# Structural Analysis Peer Review for the Static Display of the Orbiter Atlantis at the Kennedy Space Center Visitors Center

# **Structural Analysis Peer Review of the Kennedy Space Center Visitors Center Orbiter Atlantis Static Display**

**March 14, 2013**

***Figure 7.1-1. Orbiter Attach Point Compliance (Weight and Reaction Loads)***

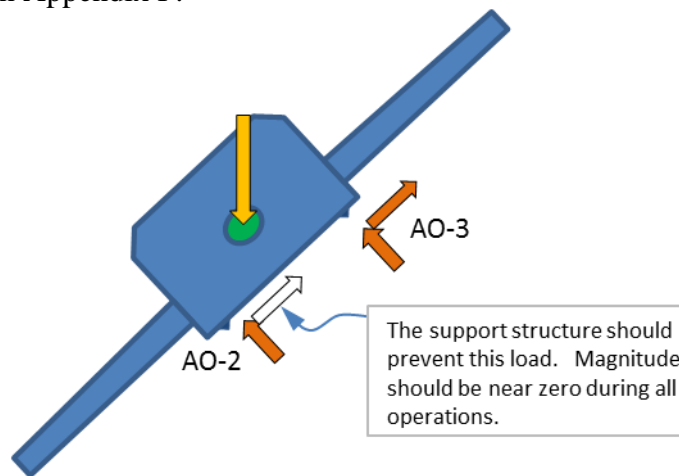
NESC Concern (Roscoe, August 17): The orbiter installation was to be performed in November and without environmental control (i.e., without the building's roof installed). Given a change in temperature event during installation or while on display, differential thermal expansion between the orbiter and the support structure drove the need for compliance between the two articles. The DNC calculations (Appendix E) predicted forces at the AO joints with perfectly compliant (i.e., zero stiffness) support structure. The DNC used Fluorogold<sup>®</sup> bearing elements to add

BRPH Response (Paquette, August 20): “We have been looking at the concerns about differential thermal expansion between the Orbiter and the Orbiter Support frame and had the following response.

- b. We have also added high capacity slide bearings at the edges of the shear lugs at the spacers to reduce friction at AO3 and AO1 in the  $X_o$  direction from the  $Y_o$  loads and at AO2 in the  $Z_o$  direction and we have considered the breakaway friction at the edge slide bearings in our calculations as well.

**Figure 7.2-3. BRPH Drawing of Orbiter in Final Rotated Position with Loads Applied to Jacks**

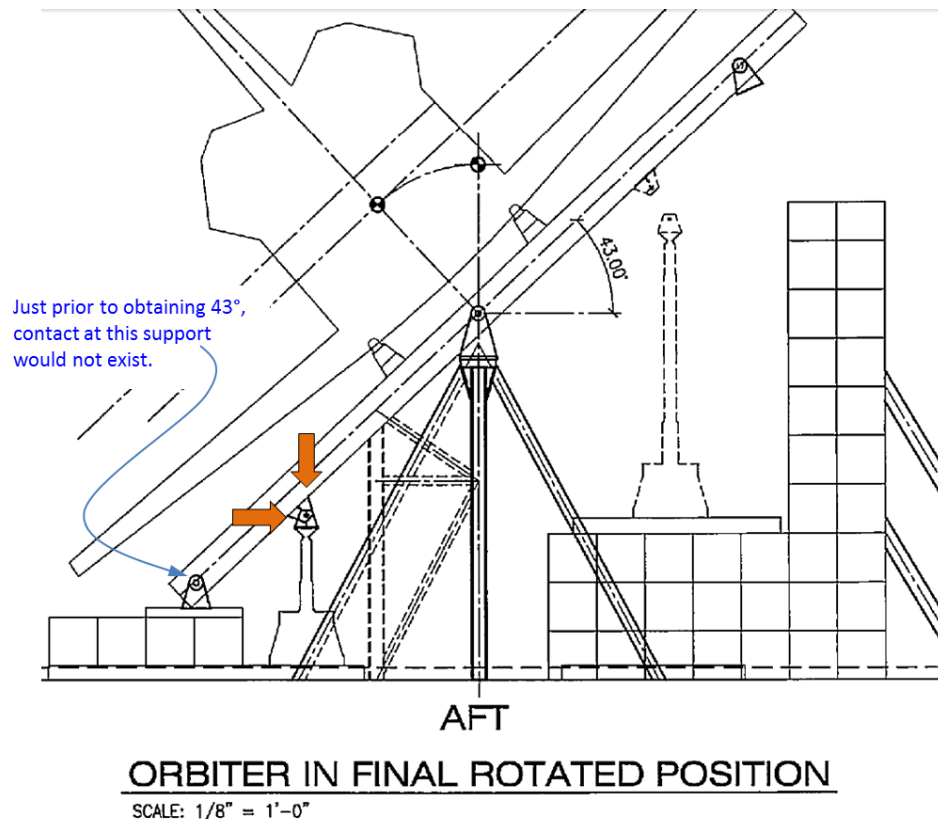
The following response was provided to the initial NESC team's comments and concerns via an email from Mr. Ken Paquette, BRPH to Mr. John Dillon, KSC-Safety & Mission Assurance Support Services (SMASS), dated July 10, 2012:

simulator to demonstrate capability and provide a pathfinder test for future processes. DNC modified their design to include load cells at the top of the jack. With the load cells, DNC were able to monitor jack side loads and improve the load control (Appendix I, item 2).

## 1. Compliance of attach points for thermal expansion

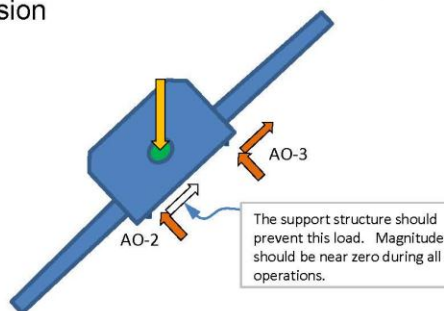
- BRPH has re-engineered their Flourogold® slide bearing design to better accommodate thermal issues as a result of NESC inquiries:
  - Contacted Flourogold® to estimate break-away friction
  - Reduced bearing area to increase pressure load to minimum recommended (overcomes static friction)
  - Removed post-installation bolt torque
  - Added slide bearings to side of shear lugs (effective when rotated)
  - Calculated predicted max break-away shear loads due to thermal expansion

## 2. Sufficient lateral stiffness of the lifting jacks

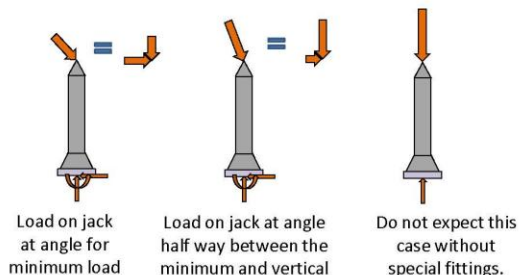
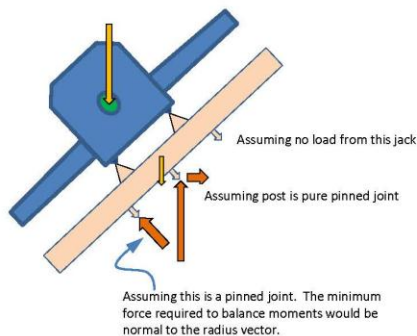
- Concern that jacks will experience a moment as the orbiter is being rotated to final position (starboard side 43 deg. down)
  - BRPH incorporating bracing, sliding tracks for jacks, and dunnage in 2" increments to control rotation.
  - Insufficient jack data to do analysis – but will demonstrate capability with testing (open work). Plan to use an orbiter mass simulator to perform pathfinder test.

### 3. Payload Bay Door (PLBD) Support Beam Factor of Safety (FoS)

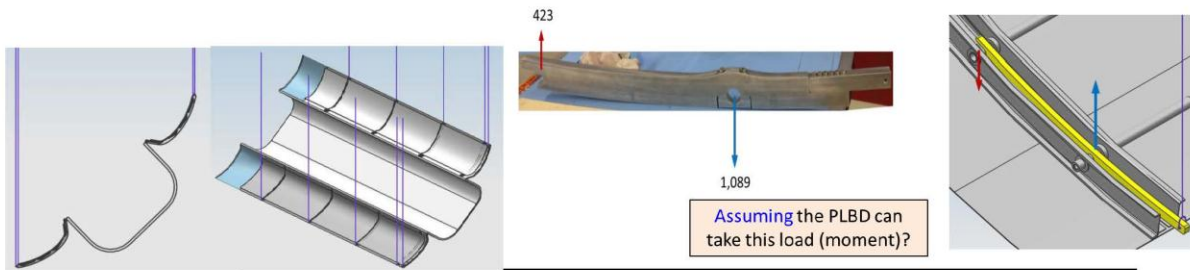
- PLBD Support Beam design was based on FoS of 2
- NESC concerned with transition of PLBDs from existing GSE to support beam & cables.
  - Weight of GSE still attached; Strongbacks make doors semi-rigid
  - Planned method to transfer load to support cables via turnbuckles
  - Should consider Support beam and cables as lifting devices during transition (NASA Standard required FoS of 5)
- USA opted to use stronger bolts and improve their analysis resulting in FOS greater than 5.

#### 4. Payload Bay Door opening operations

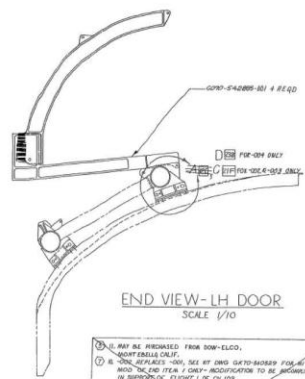
- The NESC team did not have the expertise to assess the PLBD opening operation with modified orbiter GSE (C-hook, etc.)
- Communicated concern back to S&MA and program. NASA and USA Program personnel are reviewing those activities

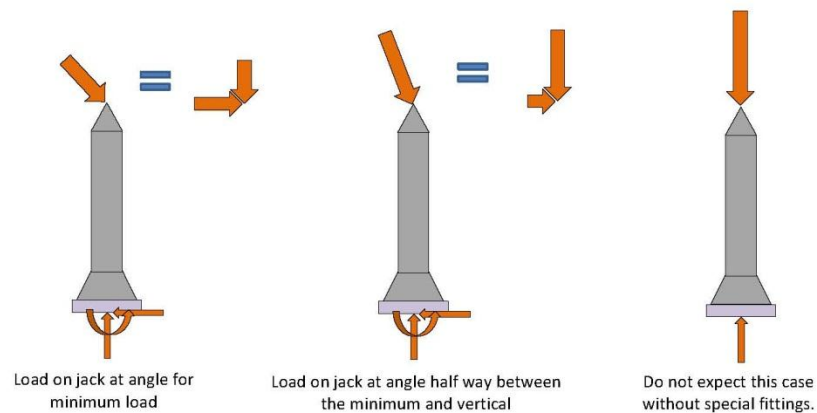
Load at top of left side jack depending on interaction of jack to frame:

If that is the case, then the horizontal component load would push the jack inboard (couldn't remove dunnage) and wouldn't stop rotating until impacting dunnage.

## Concerns/Data Required

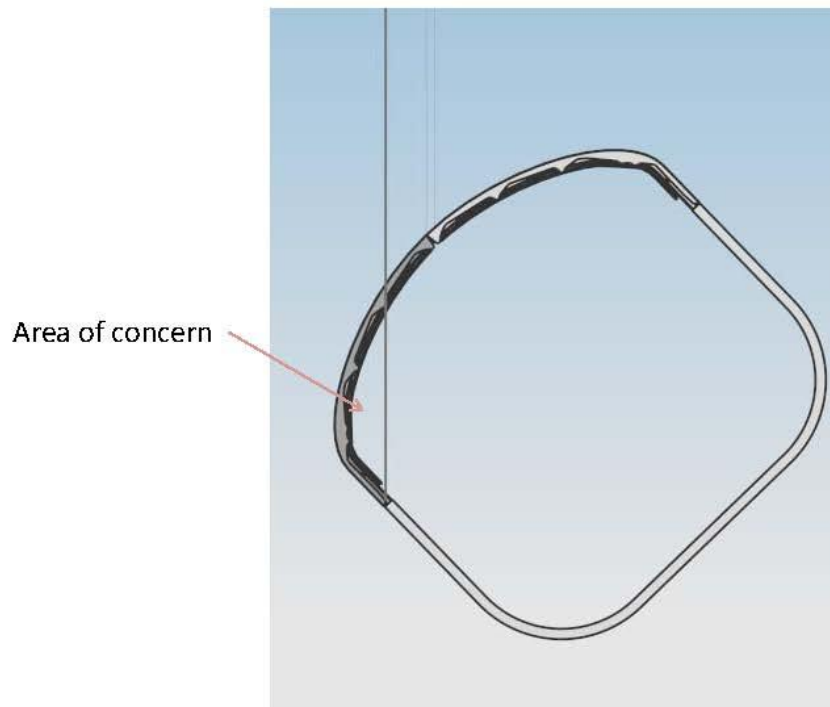
- Upper side wall deflection/stiffness
- Door mass/ center of mass
  - Left door opening when unlatched
  - Cable loading/design
- Do the panels need mid span support
  - If any left door only

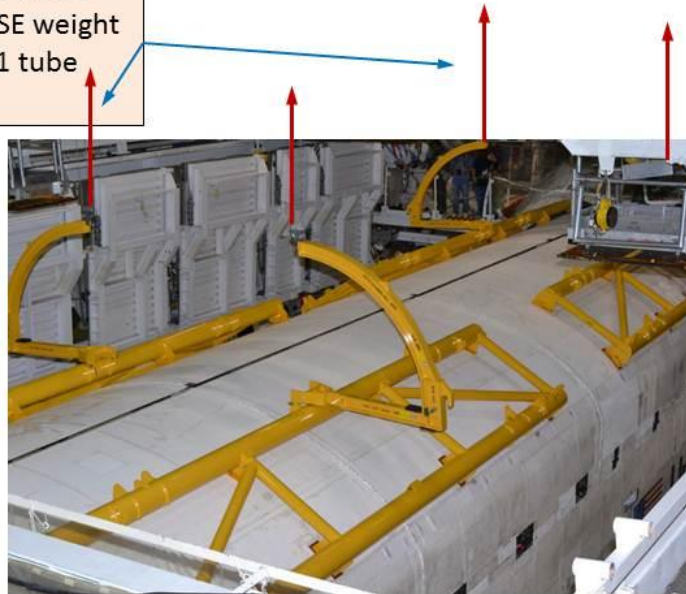
The FS of 5 should be maintained until the load can be distributed into the structure. This doesn't happen until the load is into the PLBD shear tubes. A single failure of a membrane loaded member (pin or bolt) that would result in loss of a critical lift should have FS of 5.

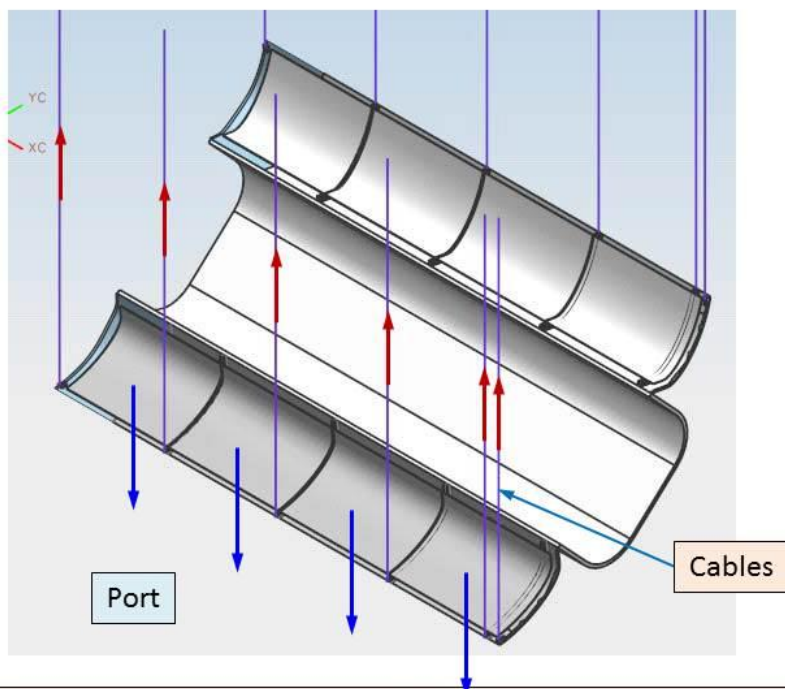
How are the turnbuckles adjusted to provide the proper load per cable? If one turnbuckle is adjusted  $\frac{1}{4}$ " shorter than needed, that turnbuckle/cable picks up additional load from the adjacent cables. Analysis *assumes* uniform distribution.

## Support Beam

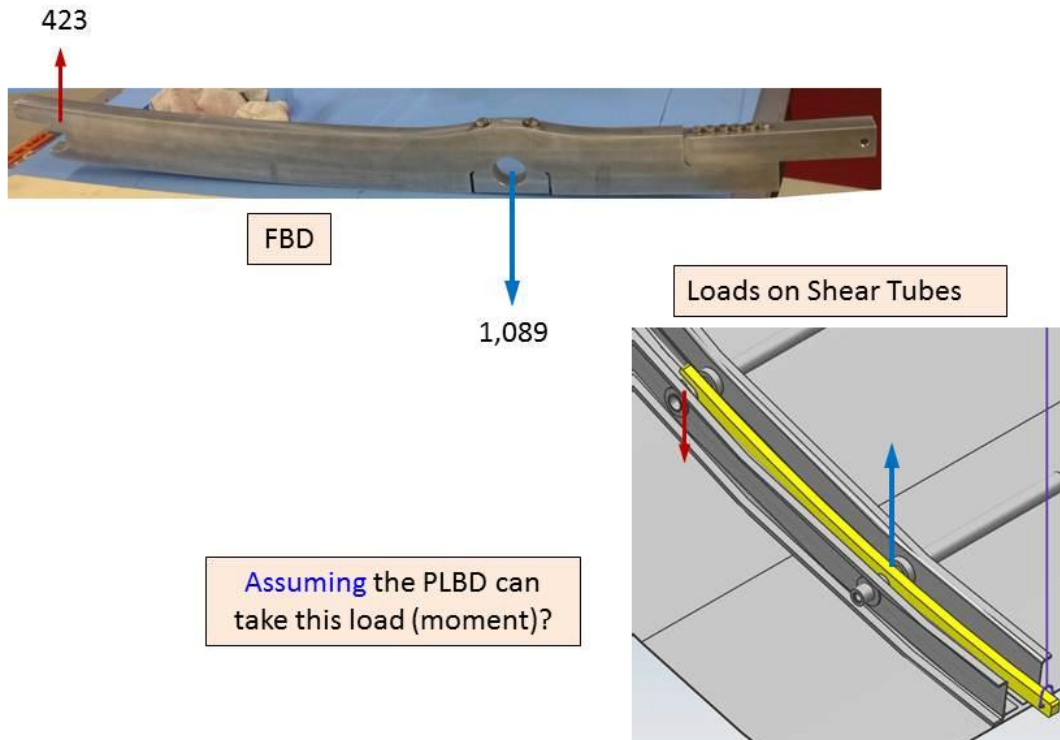
- The cables are in an indeterminate system
  - Analysis did not account for possibility of extra load
  - Cable tensioning procedure?
  - MS is dependent on Cable tensioning
- Recommend modifying 1 bolt from a 1/4" to a 3/8".  
Modifications:
  - Drill 1 hole bigger
  - Drill and tap 1 hole bigger
  - Acquire an extra 3/8" bolt
